Conceptual Site Plan Westphalia Row

CSP-07001-03

STAFF REPORT

SUBJECT: Conceptual Site Plan CSP-07001-03
 Type 1 Tree Conservation Plan TCP1-033-07-04
 Westphalia Row

PREVIOUSLY APPROVED CSP-07001-02 ILLUSTRATIVE

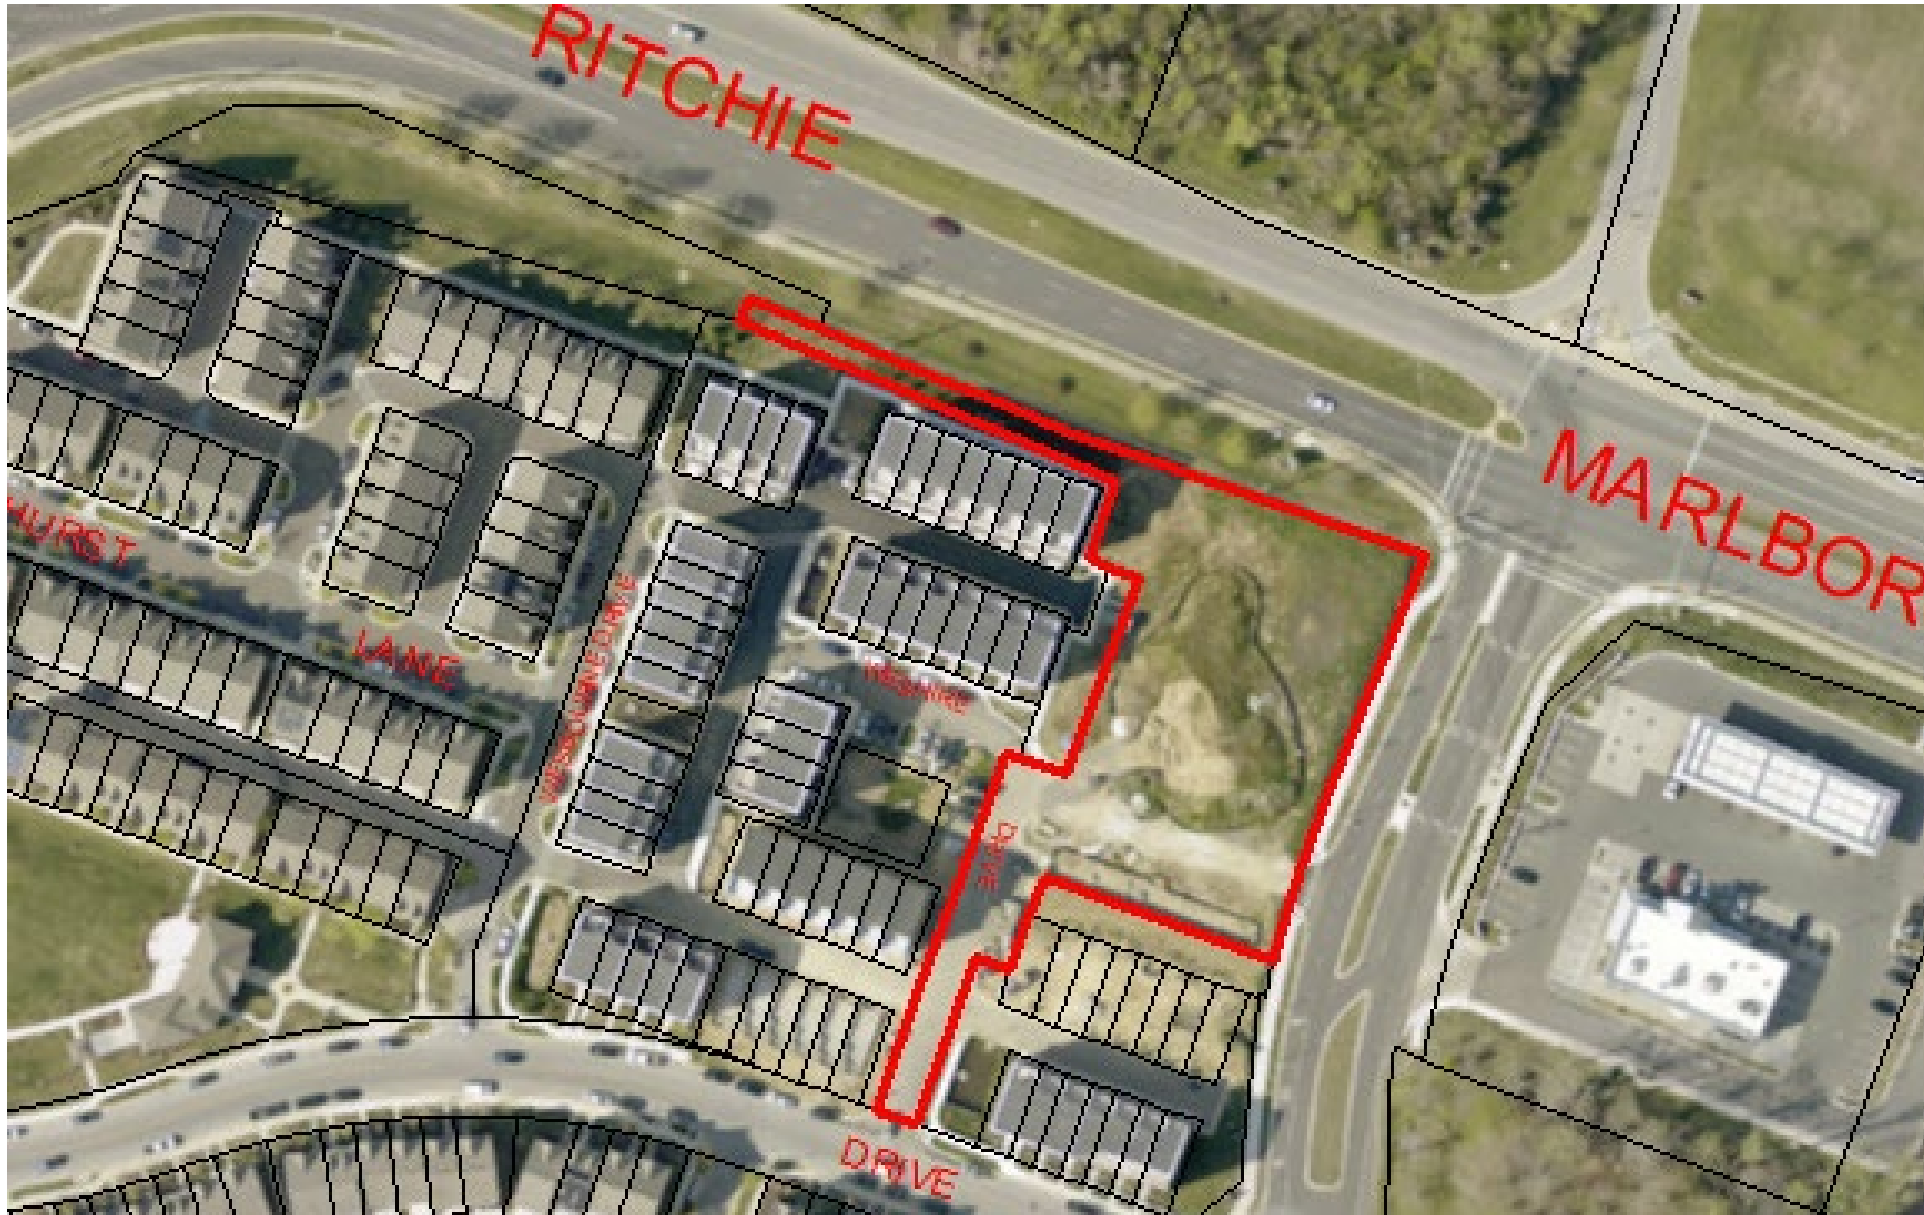
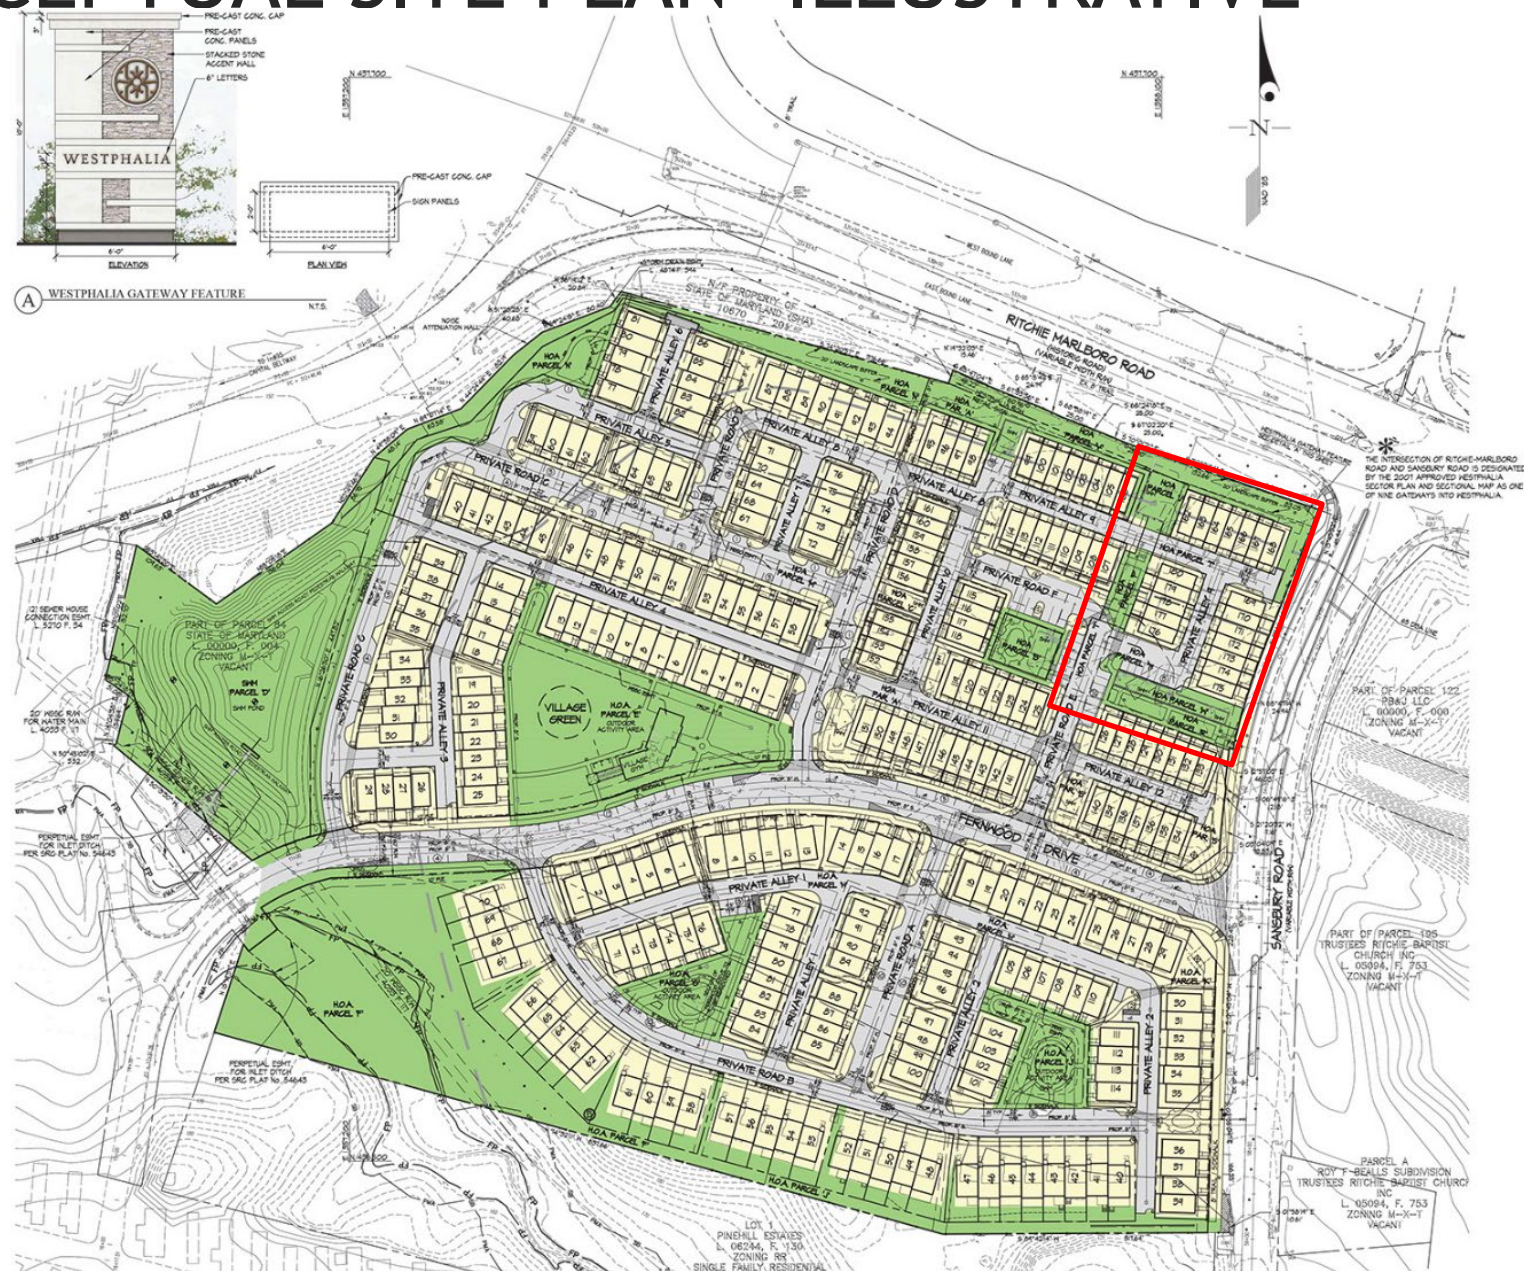
1. **Request:** The subject application proposes a revision to the previously approved conceptual site plan (CSP) for Westphalia Row by replacing the previously approved 10,000 square feet of commercial uses with 19 single-family attached (townhouse) dwelling units.

The site plan for the proposed development shows a street/alley layout that will integrate seamlessly with the road network of the existing development. Staff has no issues with future circulation of the combined development.

The submitted site plan proposes sidewalks and crosswalks throughout the site. Staff finds the pedestrian system to be convenient and comprehensively designed if additional sidewalk connections are provided to Sansbury Road, Ritchie Marlboro Road, and connecting townhomes 106 to 162. Staff also recommends an additional crosswalk be provided crossing Private Alley 9 for a continuous pathway through the site. The recommended improvements support separated pedestrian routes and a convenient pedestrian system designed to encourage pedestrian activity.

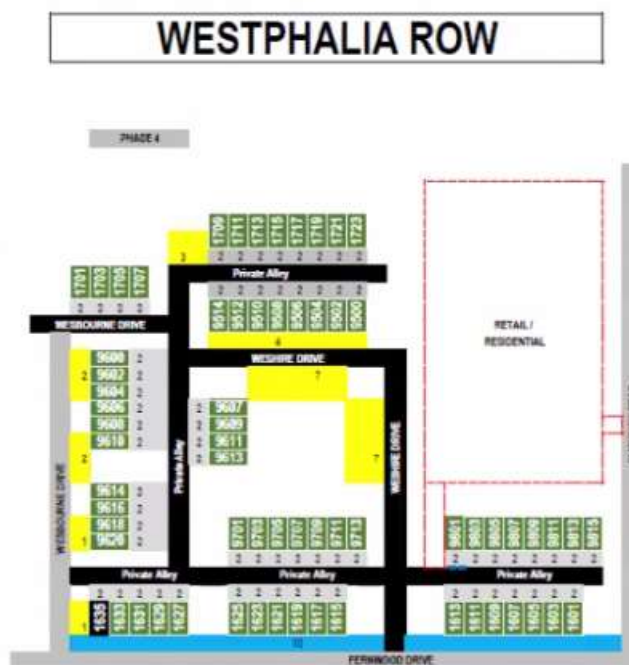
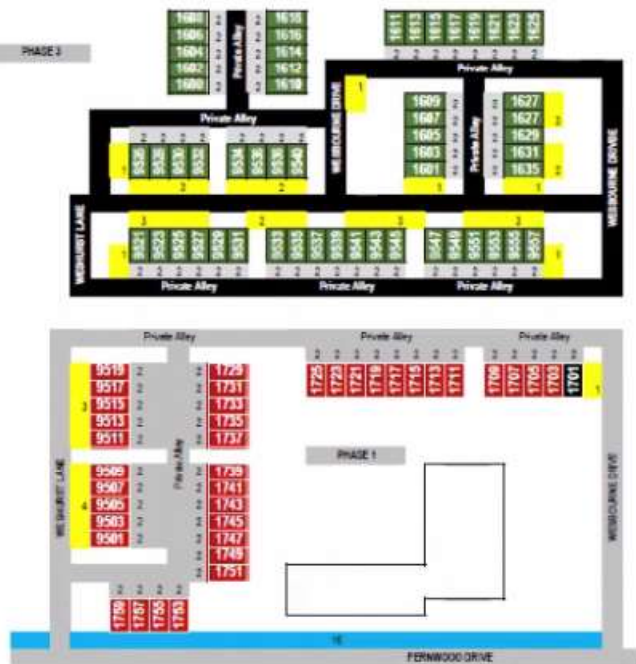
Neither of these options address the deadly traffic congestion on Fernwood Drive and the little to no parking that is available for guests and residents of the community.

I have attached a picture of Fernwood Drive that I took on the evening of April 1st, it was another accident that took place on the dangerous road. The second document I am attaching is graphic of the parking situation in Westphalia Row. The yellow spaces are guest parking and it is about 93 parking spaces for the entire neighborhood. 93 parking spaces in a community with 275 homes is horribly insufficient; that not even 1 guest parking space per home.

Neighborhood “Tot Lot” (Sole Playground Currently):

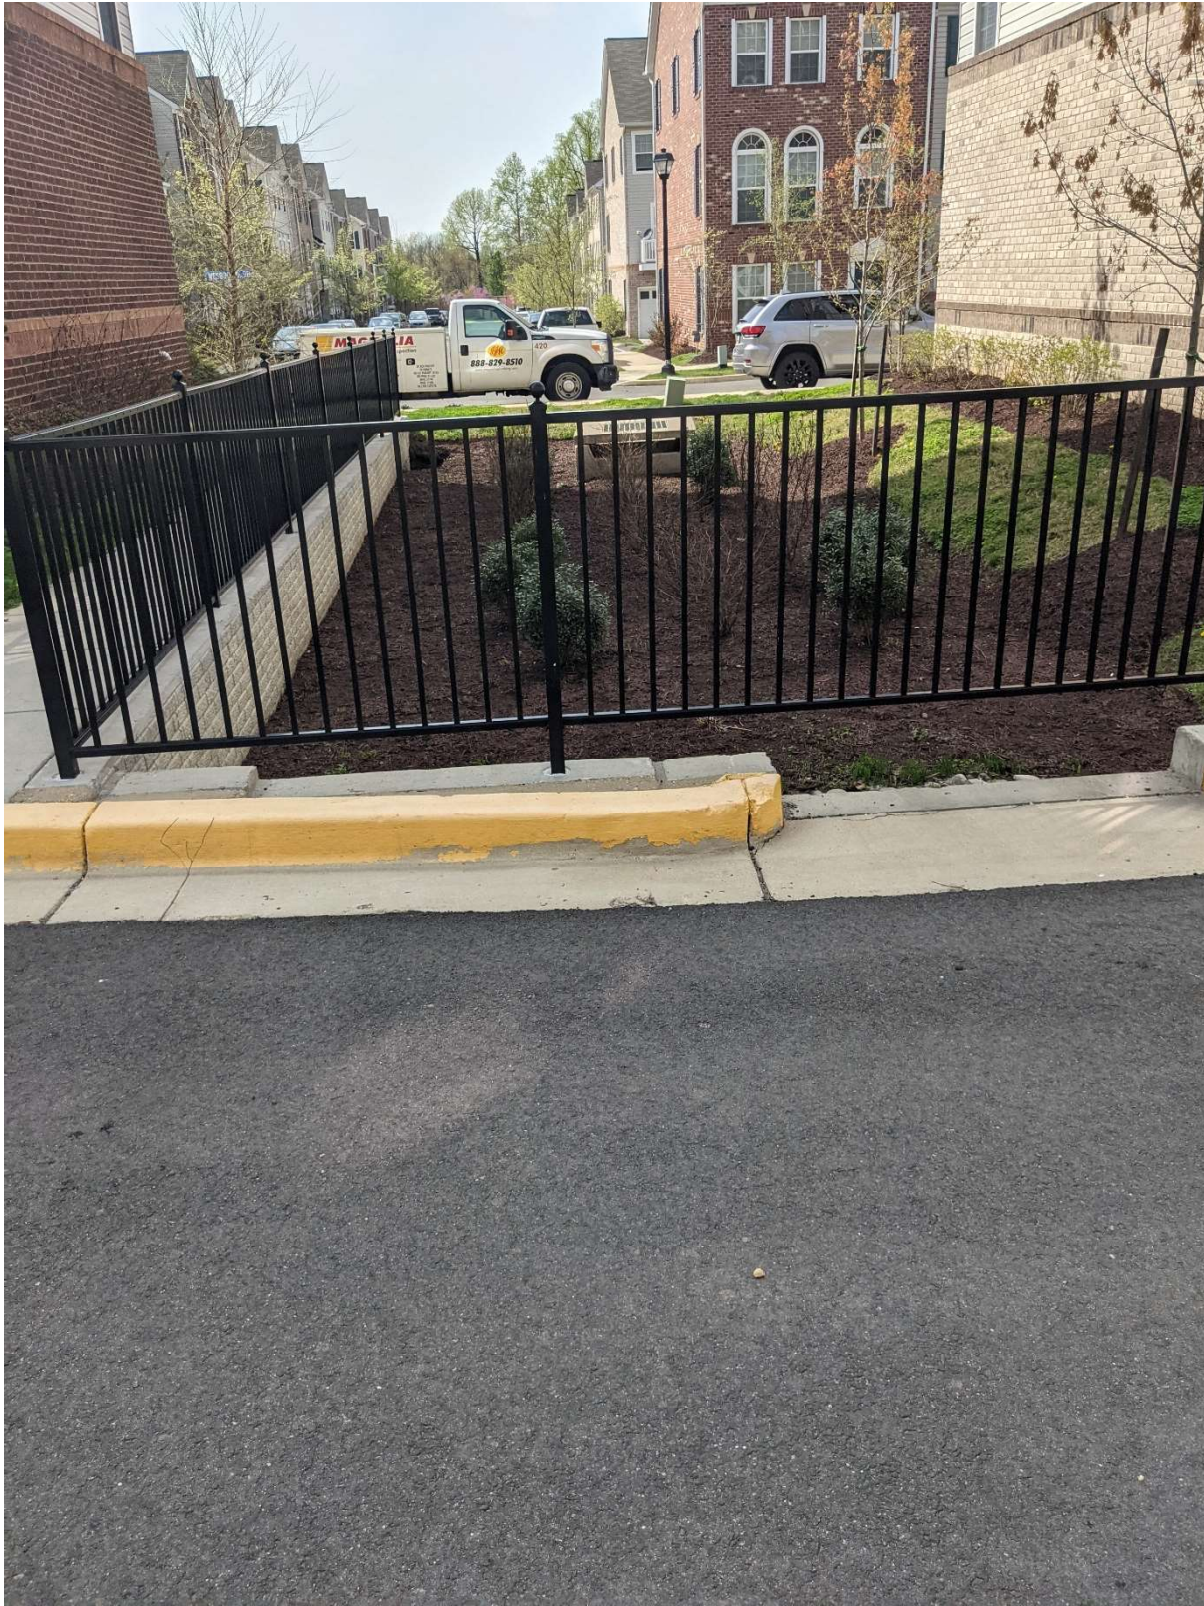
Haverford provided the above “tot lot” as sufficient play space for the entire neighborhood. Our neighborhood contains over 200 residential units to date, all of which could potentially house growing families. The above tot lot is something that the HOA is willing to review and improve once Haverford leaves development, but our HOA would not have the freedom to create new space once Haverford fills in the final open space with more homes. Adding more homes without adding more dedicated outdoor space is something many residents expressed disapproval for in our recent HOA Meeting.
